METROPOLITAN AREA PLANNING
DEPARTMENT

Re: Administrative Adjustment 99-7: Administrative Adjustment to reduce the number of required parking spaces from 121 to 110 and allow parking within the front yard setback on property zoned "TF-3" Two-Family and generally located south of 21st Street North and west of Carmen Drive.

STAFF REPORT

CASE NUMBER: CU-507

ARCHITECTURAL SITE PLAN
SCALE: 1" = 20'-0"
FILE: 21CRSITI

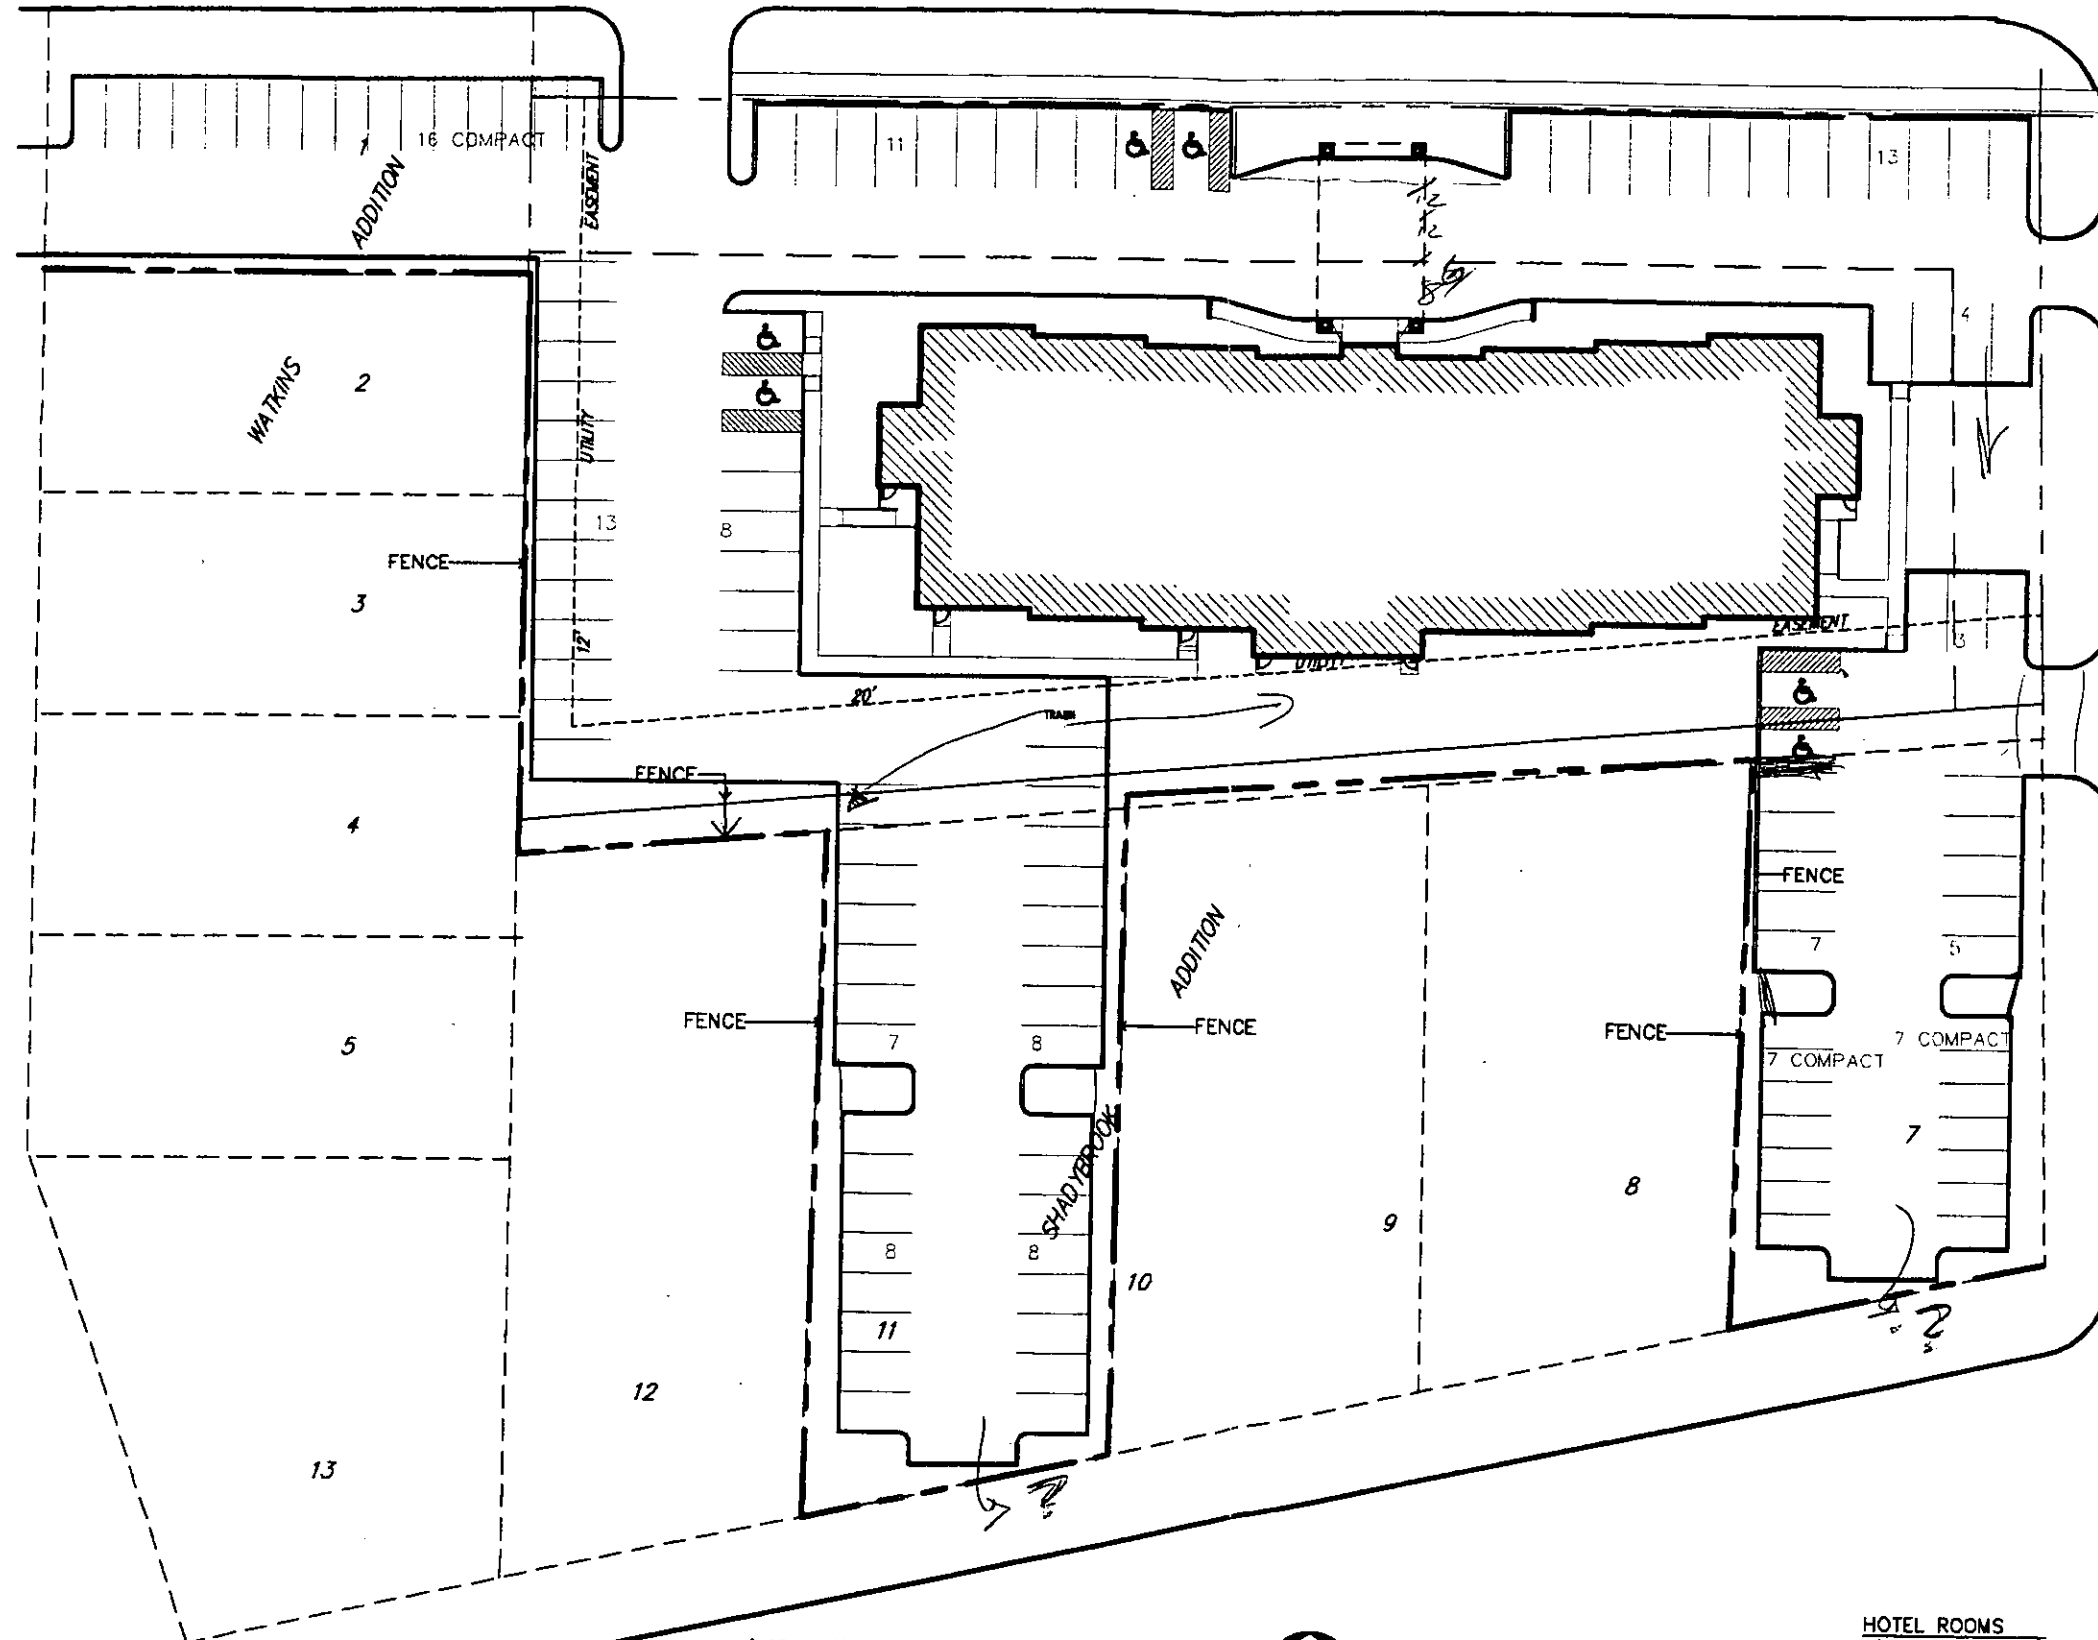
The developer is required to provide 121 parking spaces for the hotel project based on the Unified Zoning Code requirements of providing one parking space per guest room plus one parking space per 250 square feet of retail, service and office space and one parking space per 5 occupants allowed in a restaurant contained within the hotel. The amount of parking required can be reduced by administrative adjustment for commercial projects and would result in a minimum number of required parking spaces of 109 with the granting of an administrative adjustment. The attached site plan shows 110 parking spaces, with 57 of these spaces located on "TF-3" zoned property.

This request for a Conditional Use for ancillary parking is related to three additional requests. As mentioned, an administrative adjustment is needed to reduce total parking spaces required, and the administrative adjustment also should include a request to allow 5 of the spaces to be located within the front yard setback. Secondly, a variance of the "compatibility" standards to allow a total height of the hotel at 57 feet adjoining the lots to the south is being heard by the Board of Zoning Appeals. Finally, V-2156 requests vacation of the platted front yard setback from 25 feet to 12 feet to allow the canopy entrance of the hotel to extend into the required front yard setback along 21st Street.

2. Access to the ancillary parking lots shall be north onto the drive circulating around the rear of the hotel and onto Carmen Drive or 21st Street North. No openings shall be along Shadybrook Drive.
3. The site will be developed in substantial conformance with an approved site plan. Any violation of the above stated conditions shall render this "Conditional Use" permit null and void.

- 1) The adjustment for placement of spaces in the front yard setback shall apply to only those portions of the front yard setback along Shadybrook Lane as shown on the revised site plan submitted with this request.
